Land to the Northwest Of Factory Road, Northfleet Works, The Shore, Northfleet, Gravesend, Kent

Project/File: 332612492
Date: 24th July 2025
Prepared By: K State
Reviewed By: J Lewis
Subject: **Transport Technical Note 2 – Response to Comments from Kent County Council**

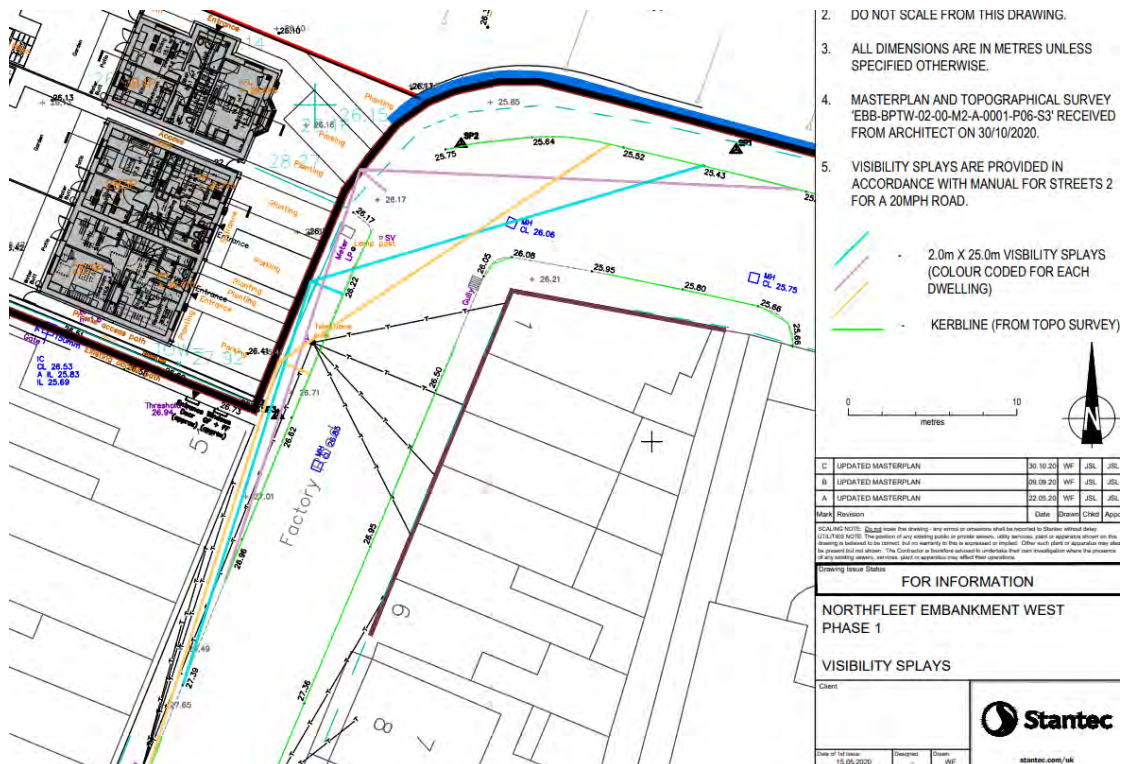
The pedestrian splay to the south of the non-designated bay is substandard at 1m x 1m. It is recommended that the hatched area on the northern side of the bay is relocated to the southern side of the bay to increase the splay to the required 2m x 2m. This could also improve accessibility for mobility-impaired users.

2.10 1m x 1m is the minimum standard for pedestrian visibility as set out in the Kent Design Guide. The design of the development achieves 1.4m x 1.4m visibility as shown in the amended visibility drawing in **Appendix D**. The location of the southern parking bay is restricted by the telegraph pole on Factory Road.

PEDESTRIAN VISIBILITY SPLAYS

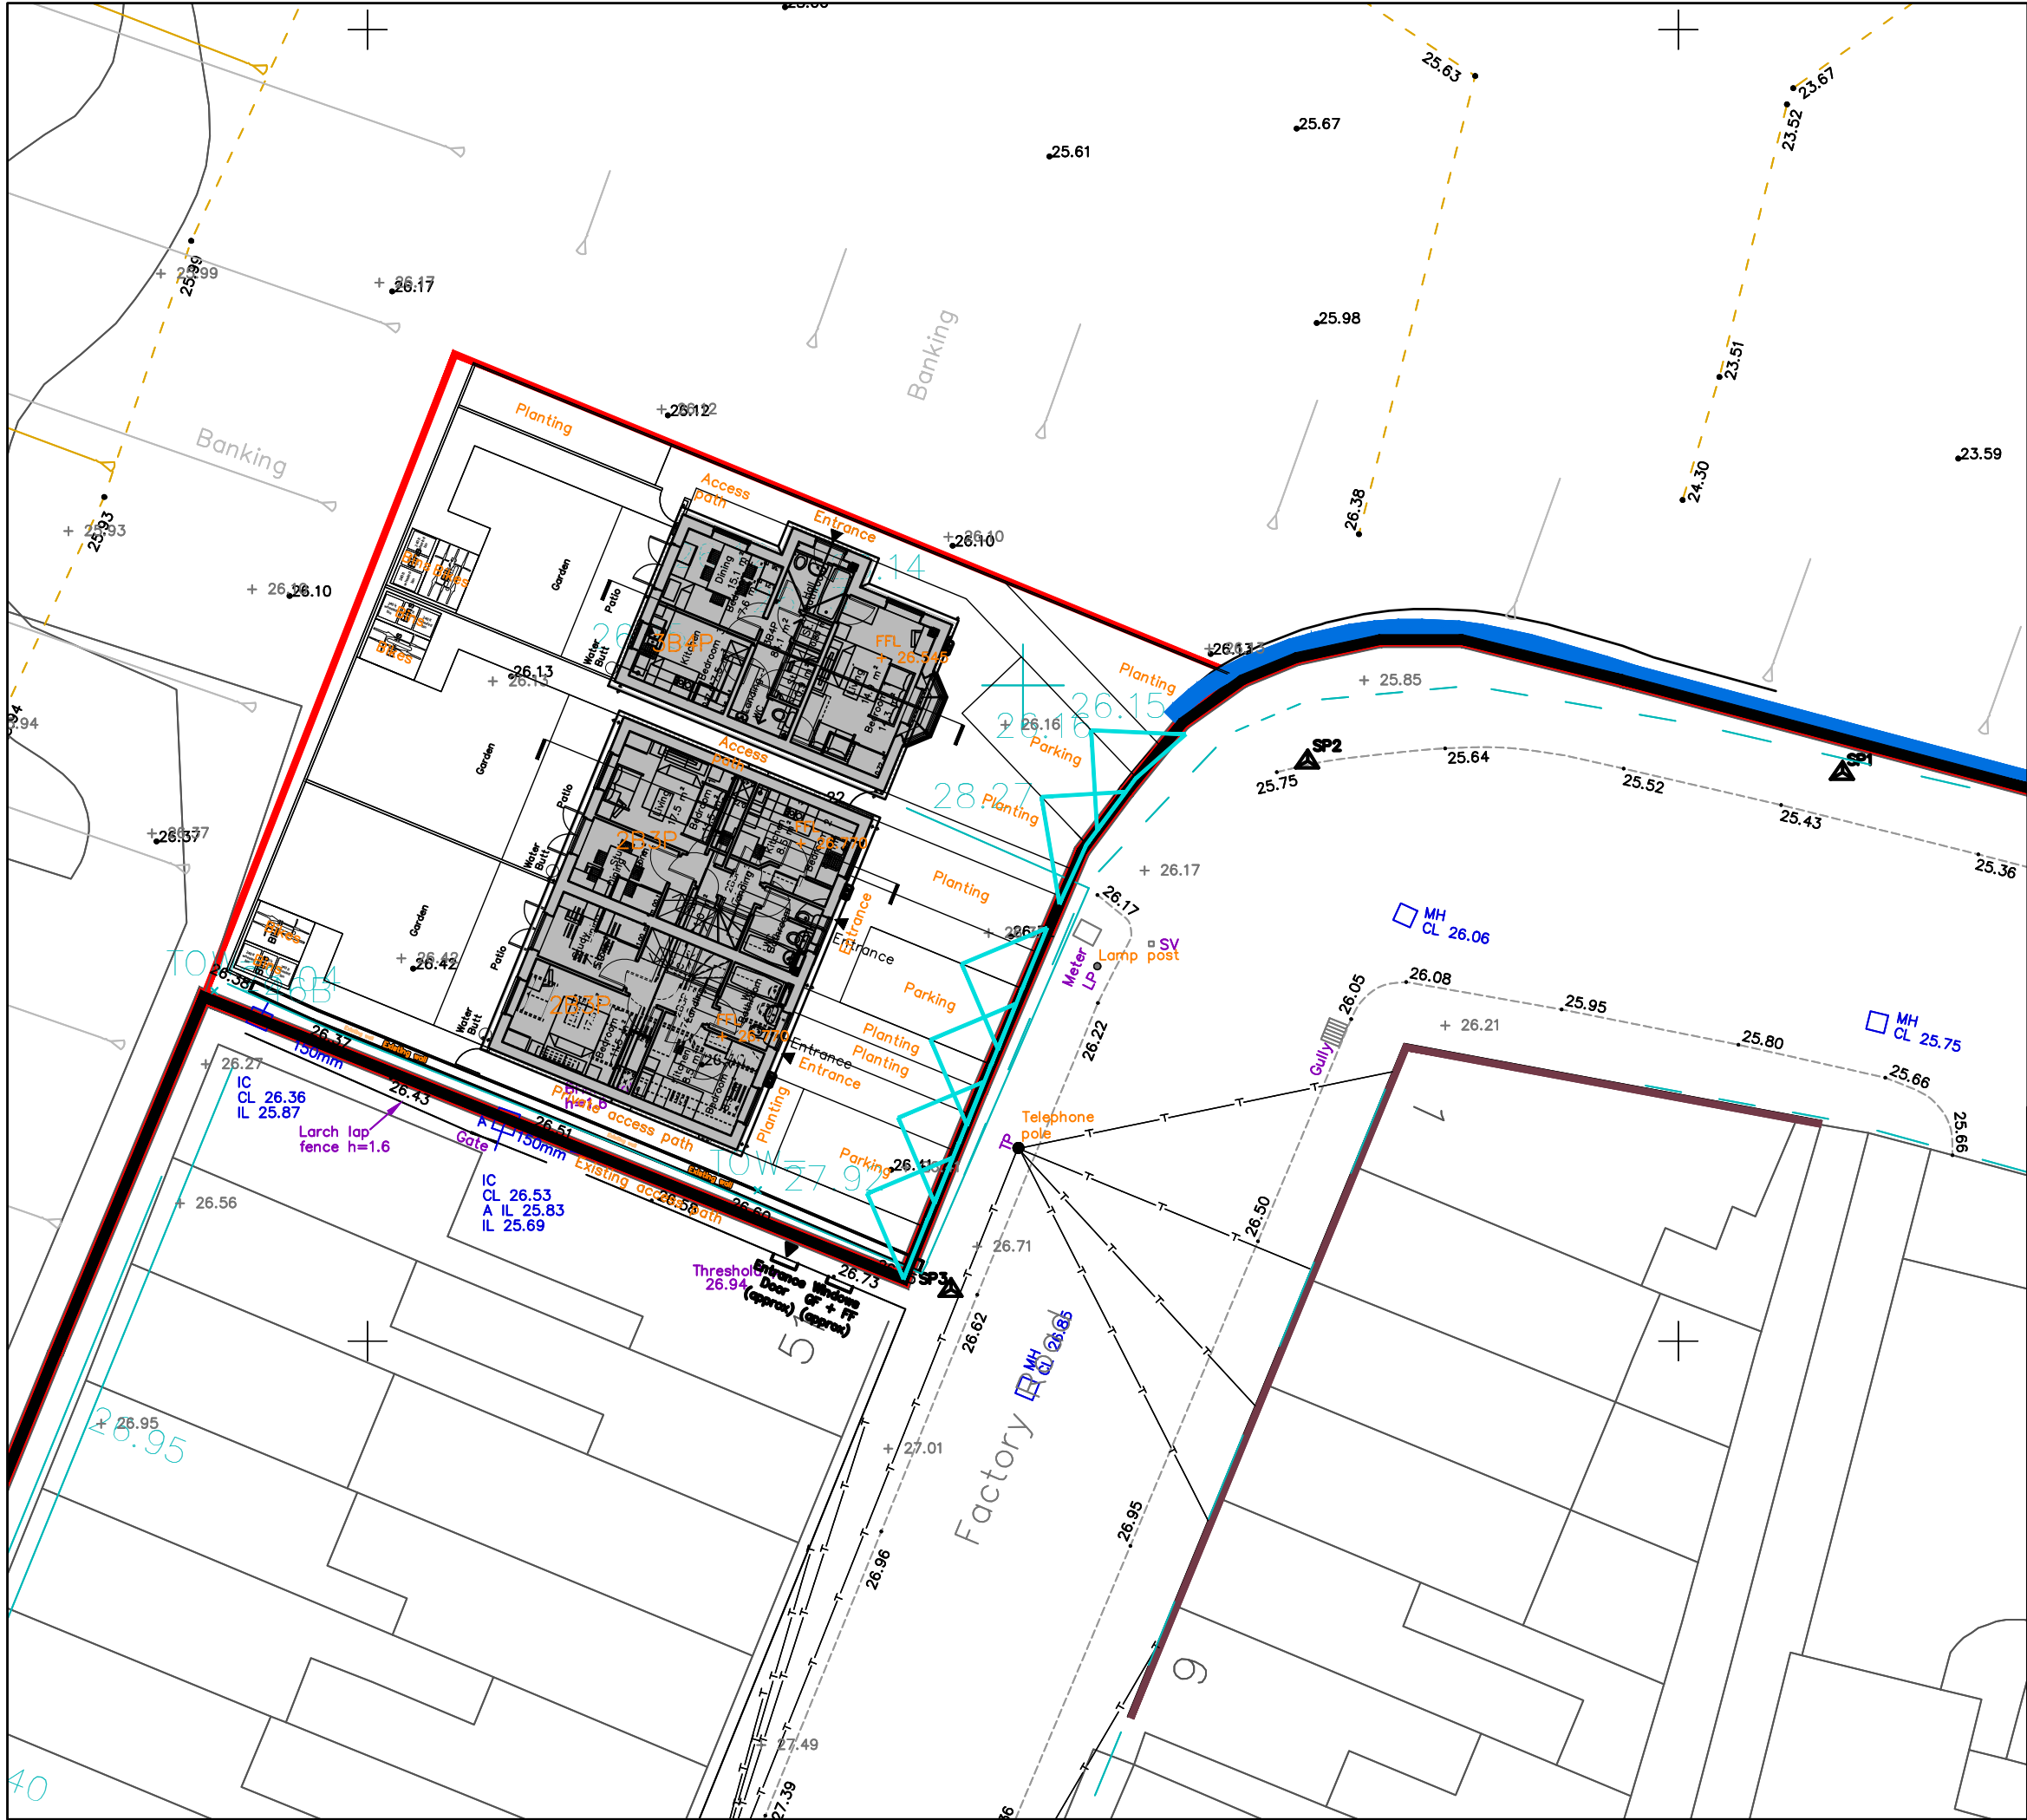
The vehicle visibility splay is shown as 2.4m x 25m, which is the requirement for a 20mph road. However, whilst vehicles are likely to be travelling slowly on approach to the bend, Factory Road is subject to a 30mph speed limit and therefore the splay should be increased to the

required 43m, or evidence provided to demonstrate that the 85th percentile speeds are within 20mph.

- 2.11 Vehicle visibility splays have been shown in line with the approved scheme for 3 dwellings (planning ref: EDC/20/0076) for a 20mph road. Please see the approved visibility splays below and in **Appendix B**. Due to the location of the development adjacent a 90° bend, speeds of vehicles travelling along this section of Factory Road are not anticipated to exceed 20mph, which is considered an appropriate speed for visibility splays and accords with the visibility splay speeds previously employed by KCC Highways in the approval of the scheme for 3 dwellings at the site.

ON-STREET PARKING

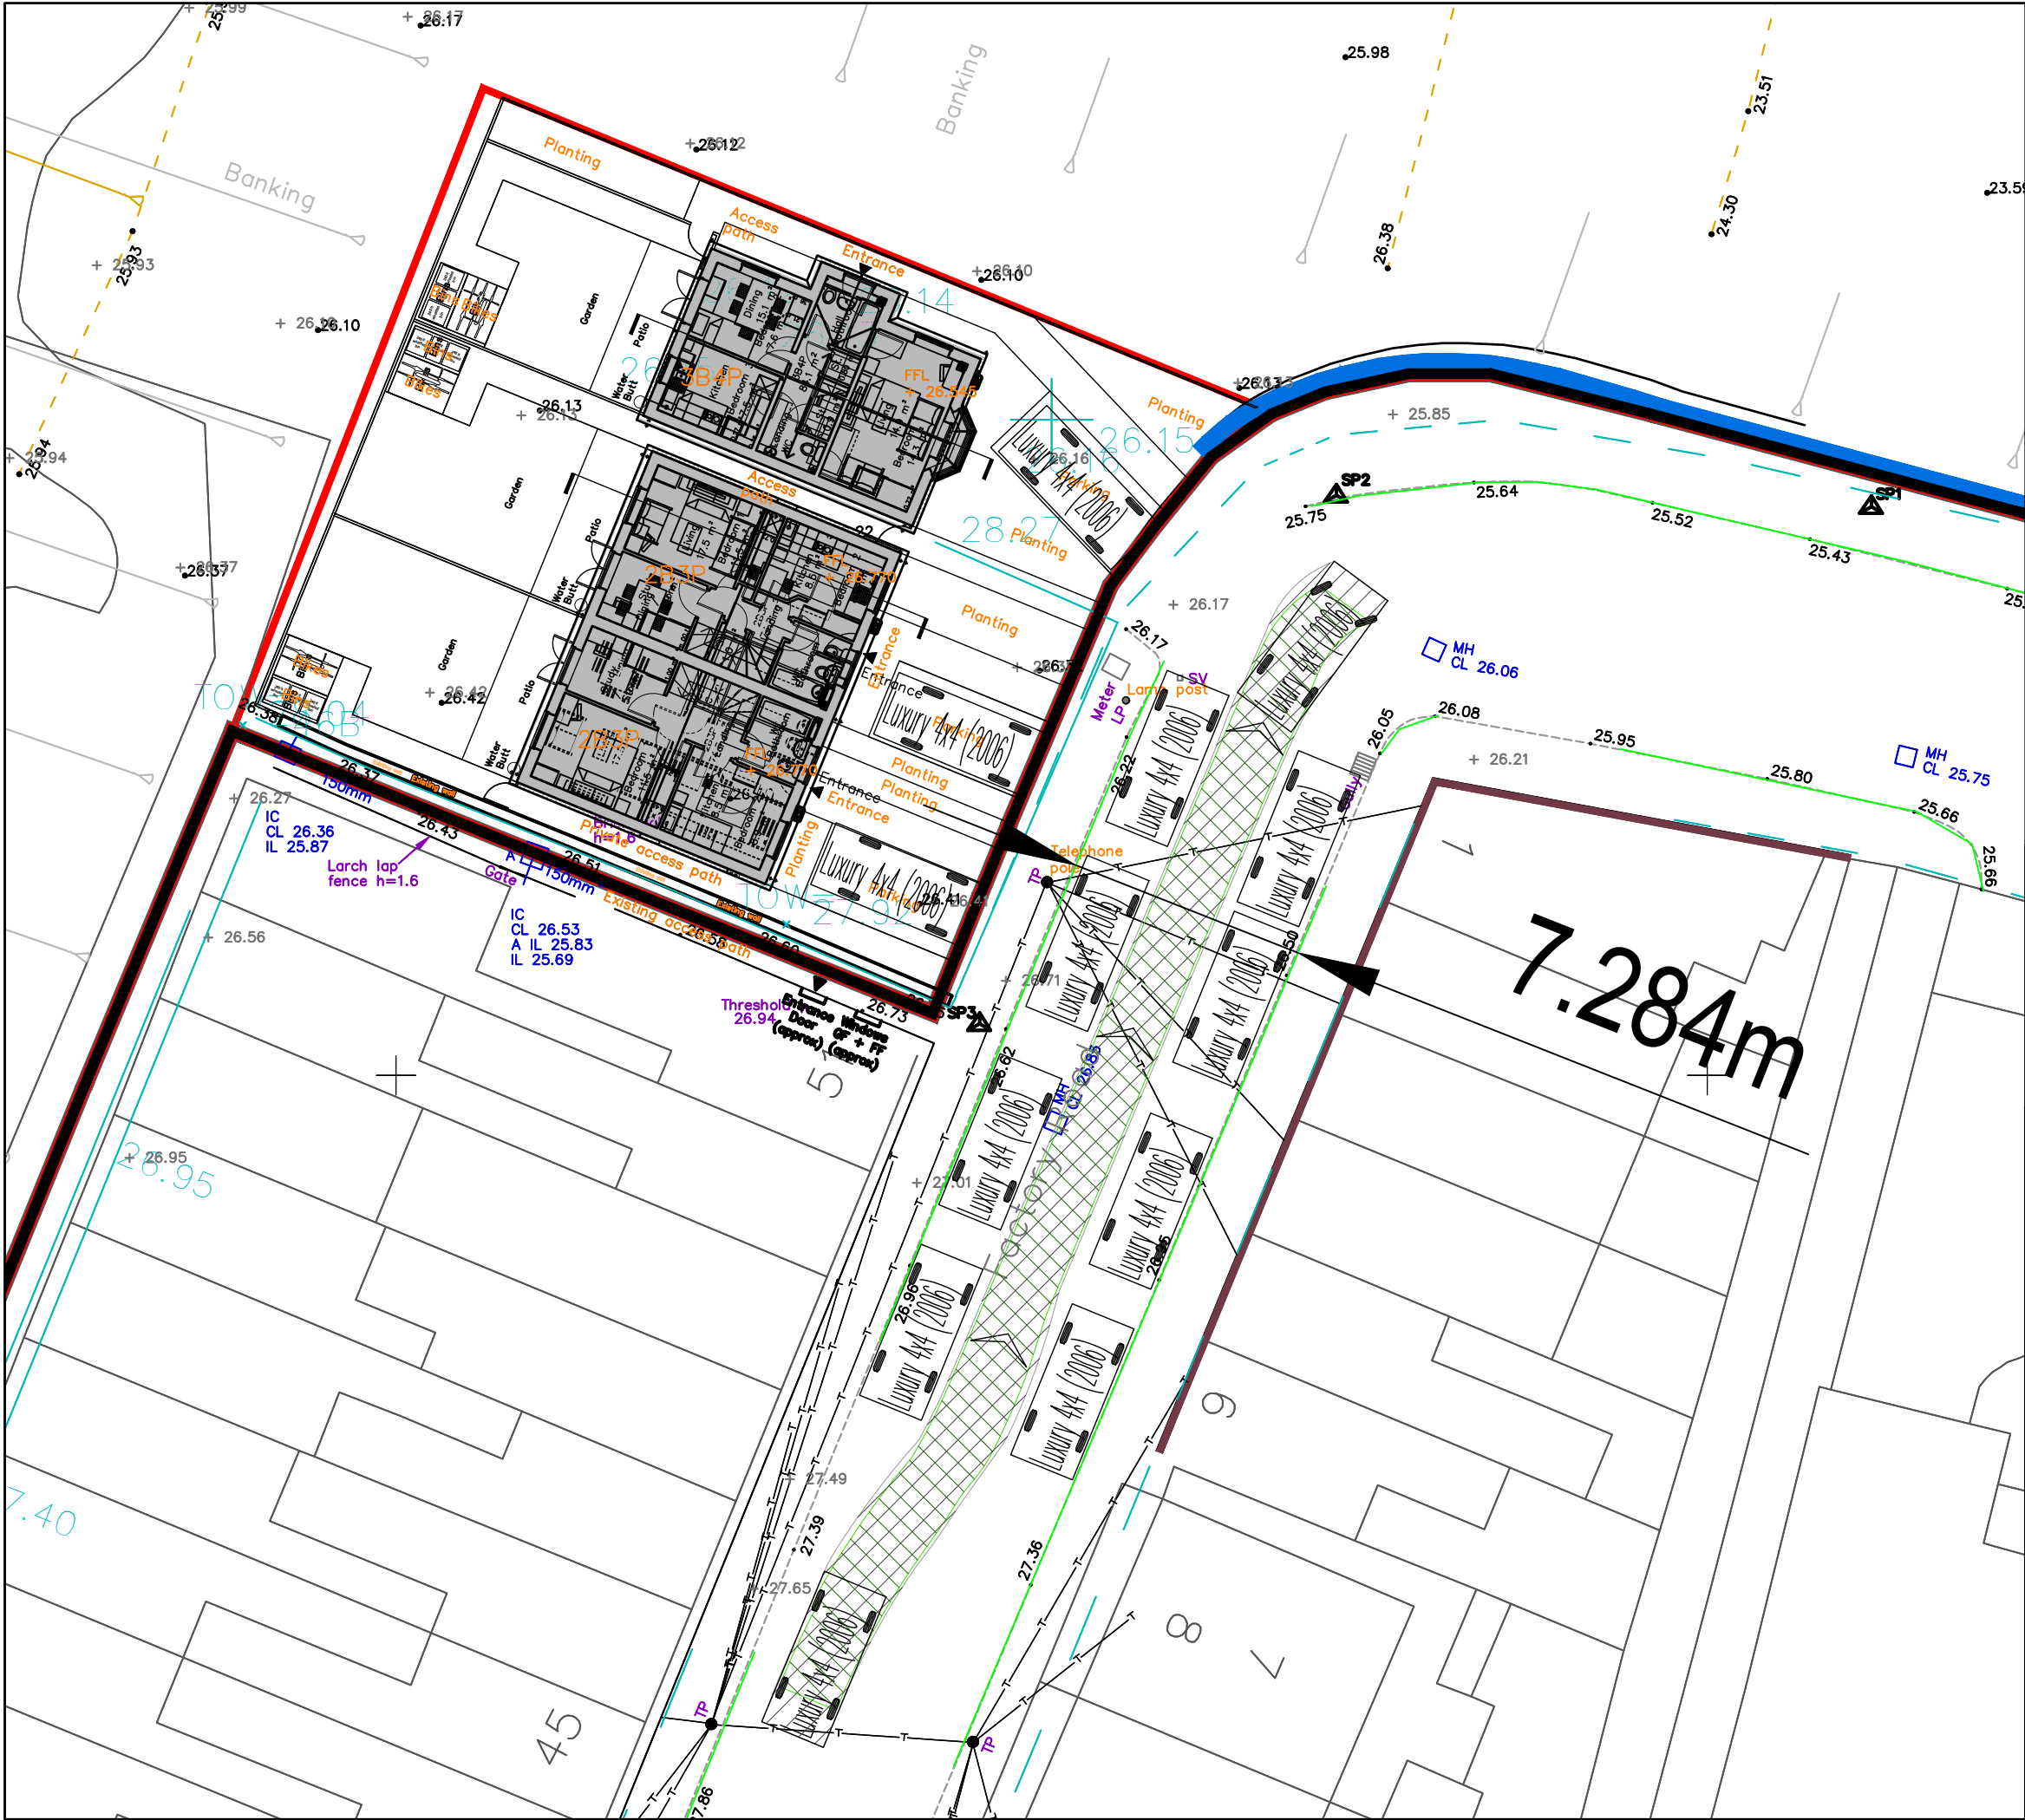
It is questioned why the two parking bays currently located on Factory Road could not be switched with the building, allowing all parking to be provided to the rear of the building, accessed from the existing bell mouth. This would enable the building line to align with the existing residential dwellings on Factory Road, allow more room for turning vehicles on site (noting that current vehicle tracking is acceptable), and retain existing on-street parking.

- 2.4 The scheme remains consistent with the previously approved development at this site for 3 dwellings (planning ref: EDC/20/0076). This approved scheme proposed three parking spaces at the front of the dwellings which broadly reflect the locations of the two parking spaces and car park access proposed as part of this development. The approved scheme design and transport documents are provided in **Appendix B**, with the approved tracking drawing shown below:
